**RFP Title: Site Improvements at Roger Williams Park Event Pavilion**

**Addendum #: 1**

**Issue Date: 01/23/2024**

The purpose of this addendum is to extend the bid opening and answer questions from the Pre-Bid meeting.

**EX. CONDITIONS/DEMO PLAN**  
SITE IMPROVEMENTS AT ROGER WILLIAMS PARK EVENT PAVILION  
1000 ELMWOOD AVE, PROVIDENCE, RI

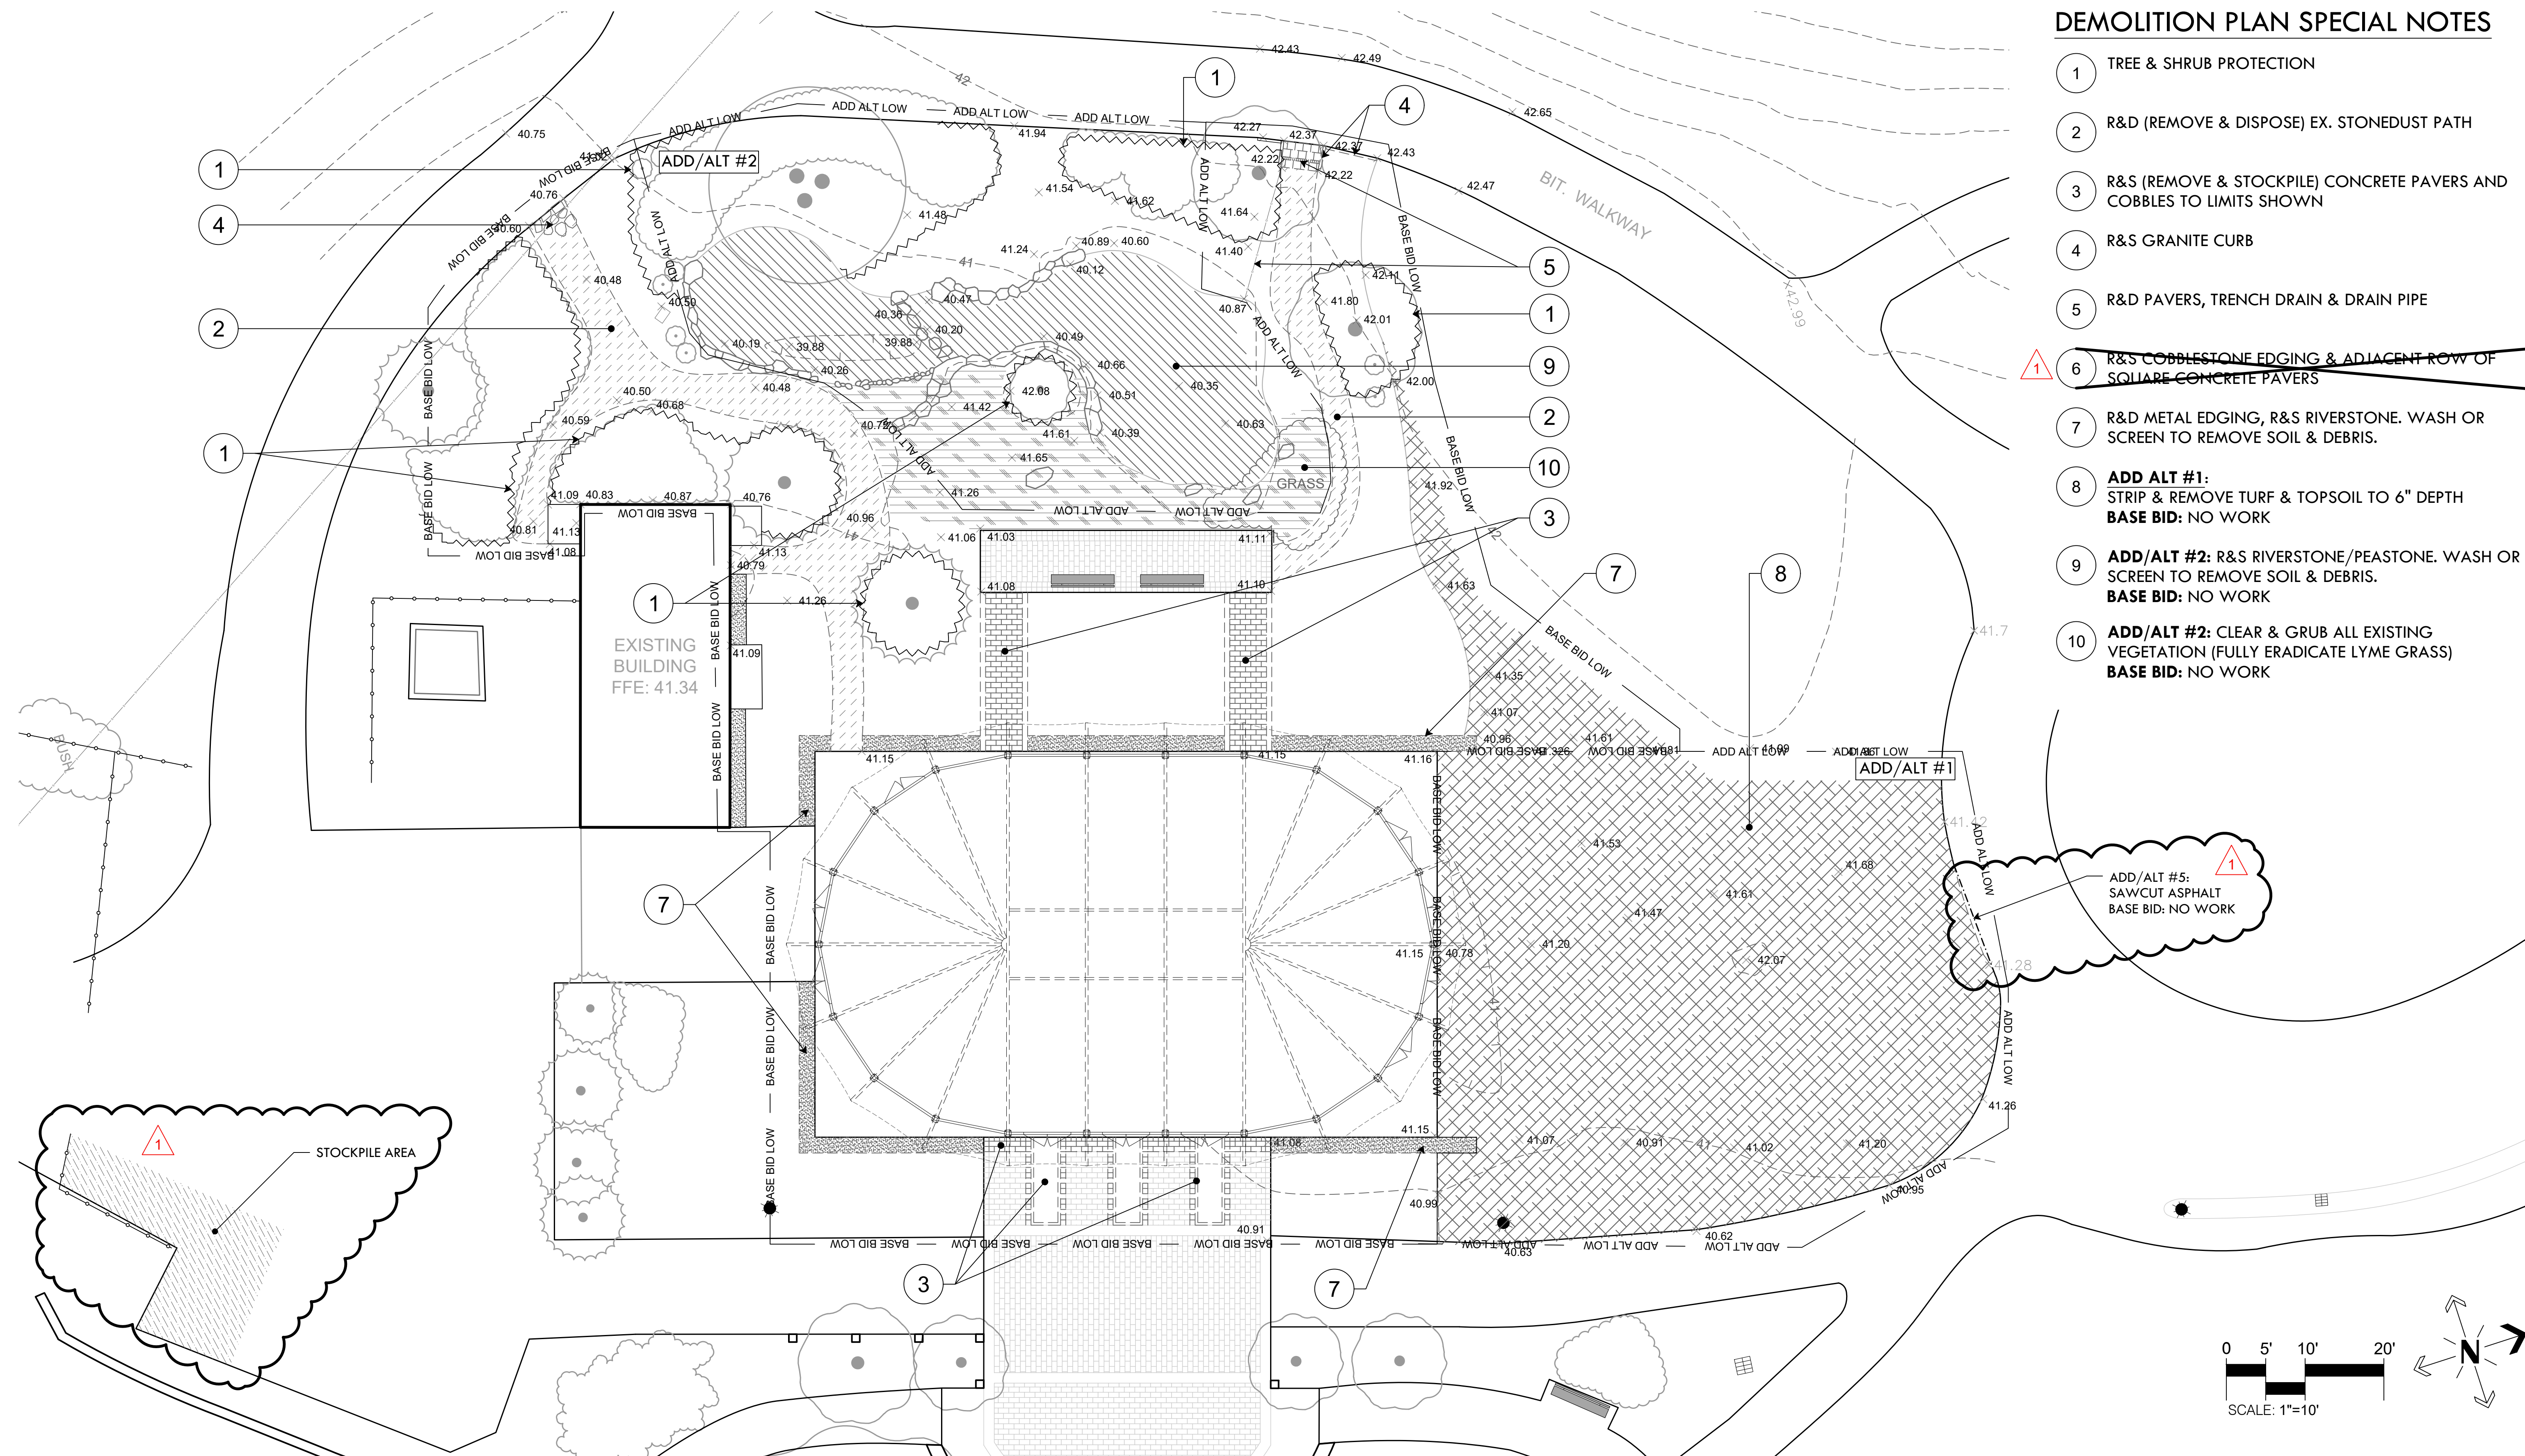
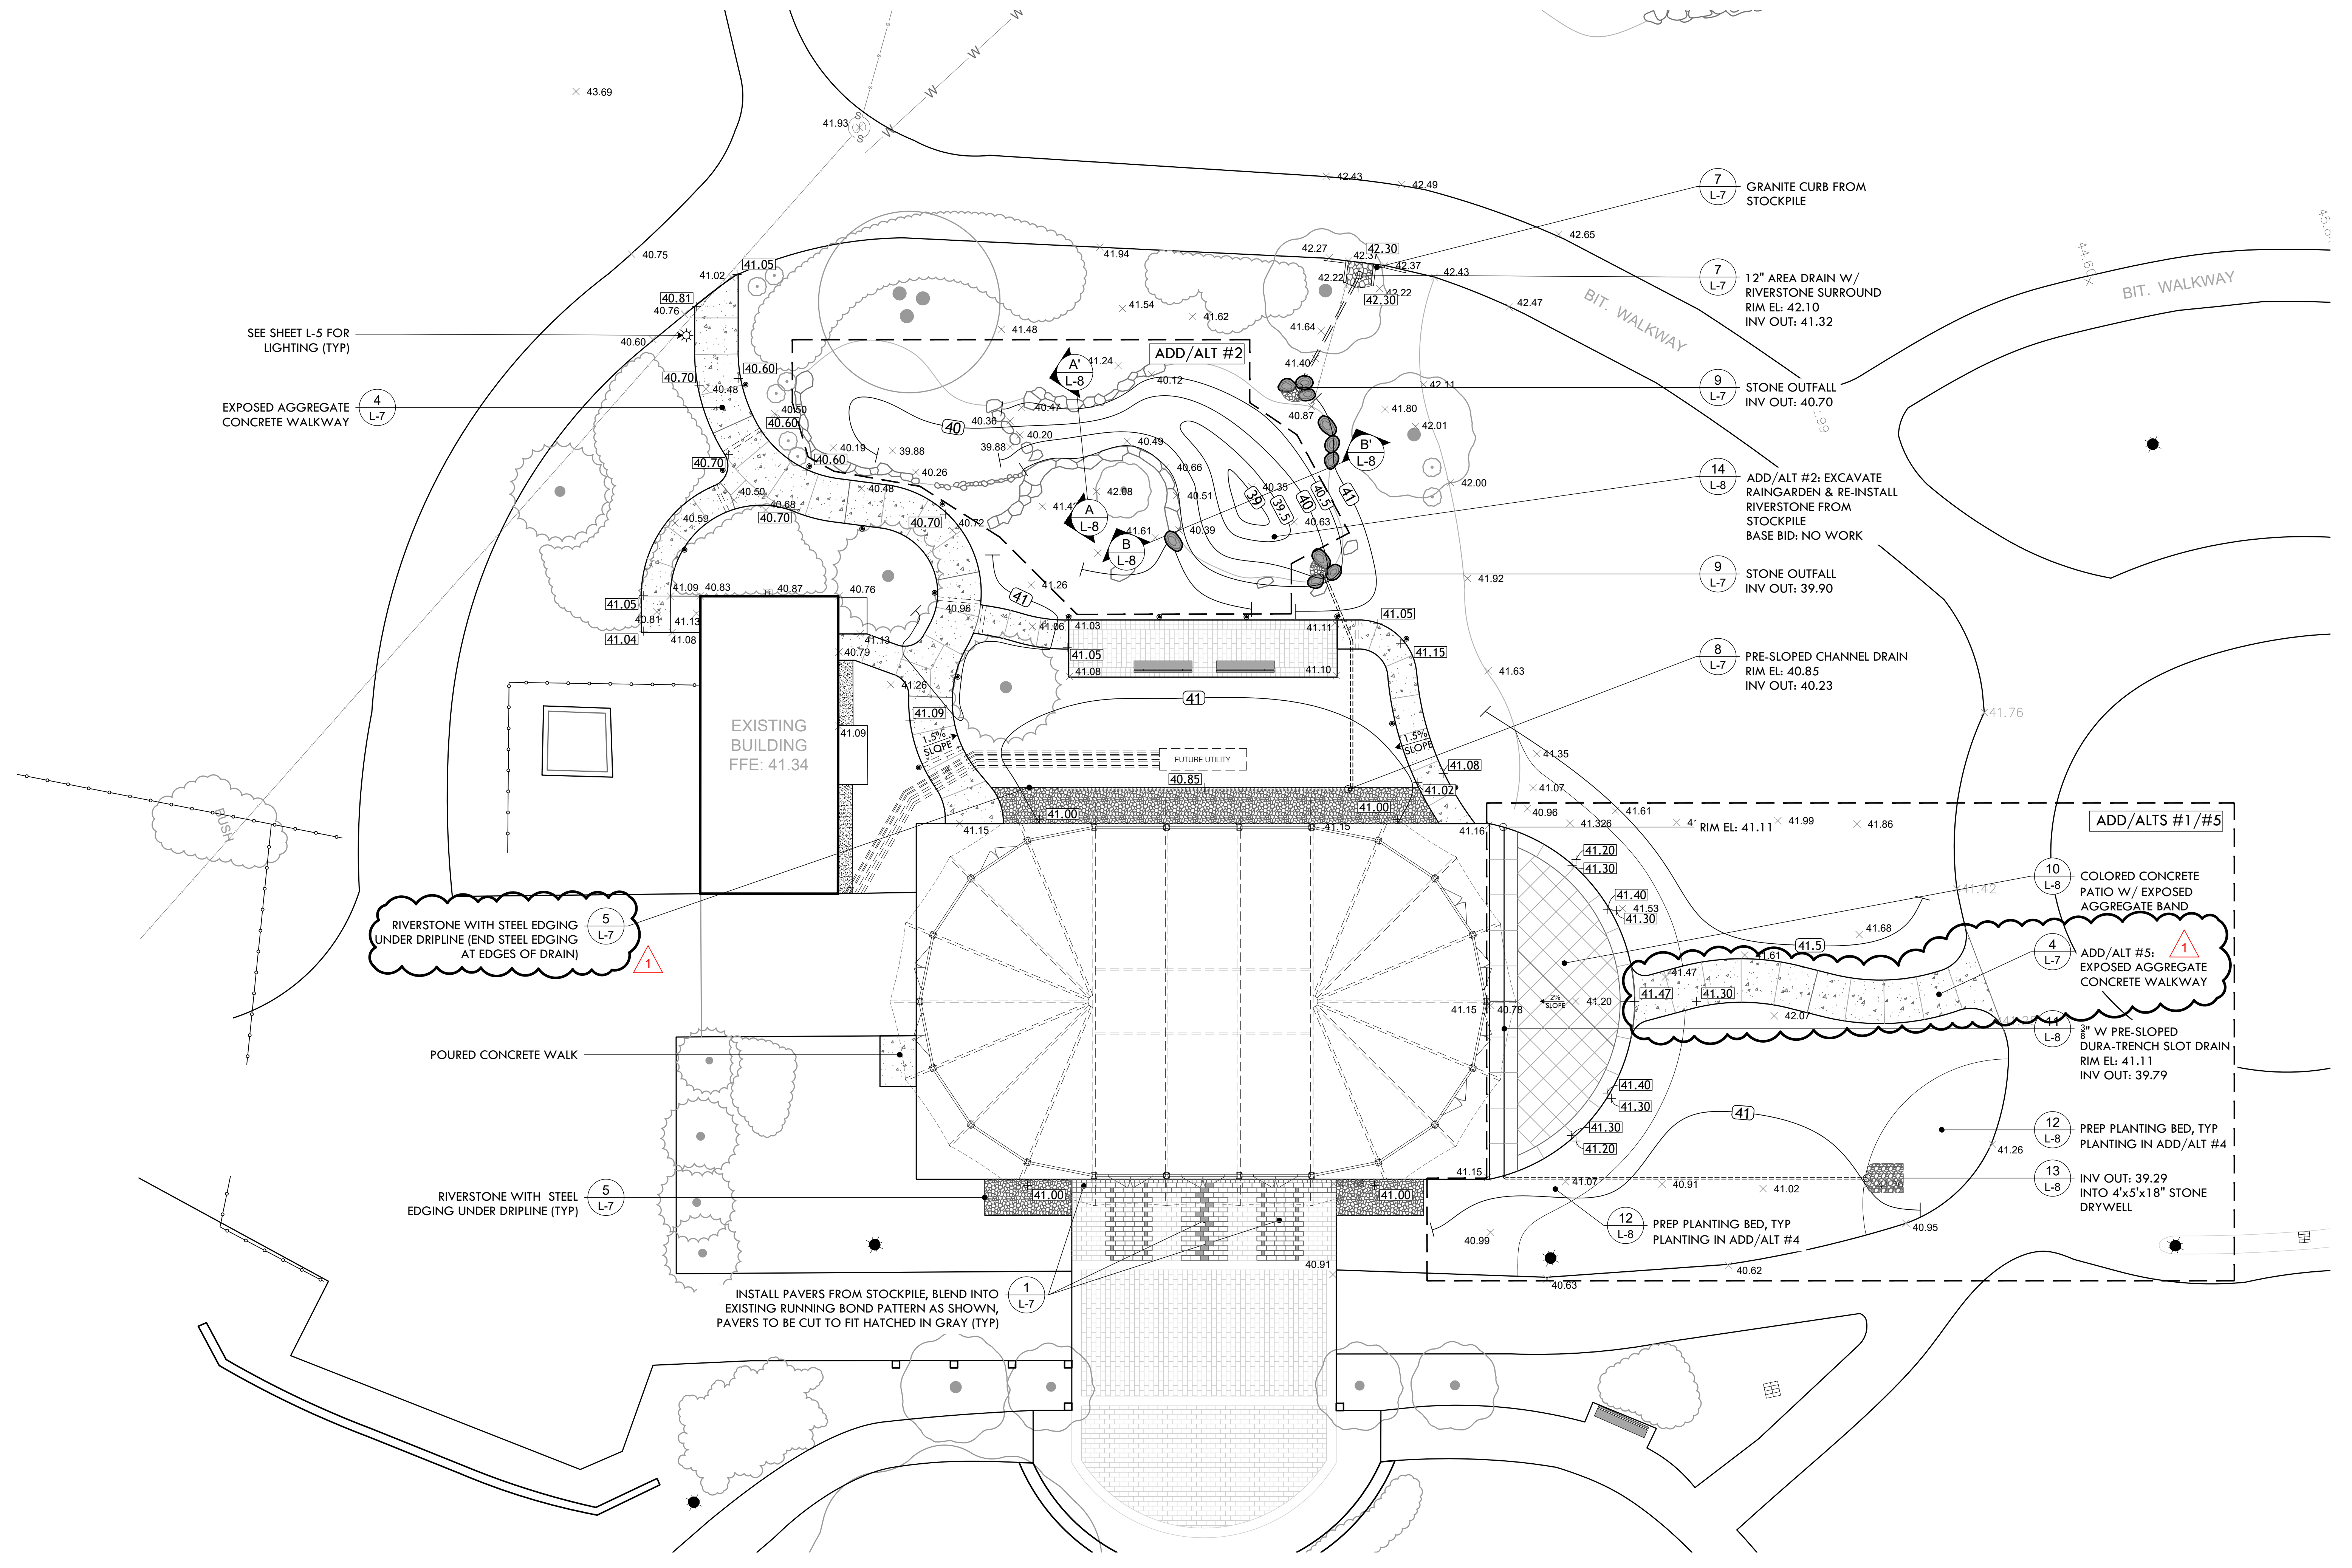
8. *Q: On sheet L2, item #6 is R&S cobblestone edging. However, there is no callout for it.*

**A: That is a redundant callout, to item #3, I have added a Stockpile area, now noted on L-2**
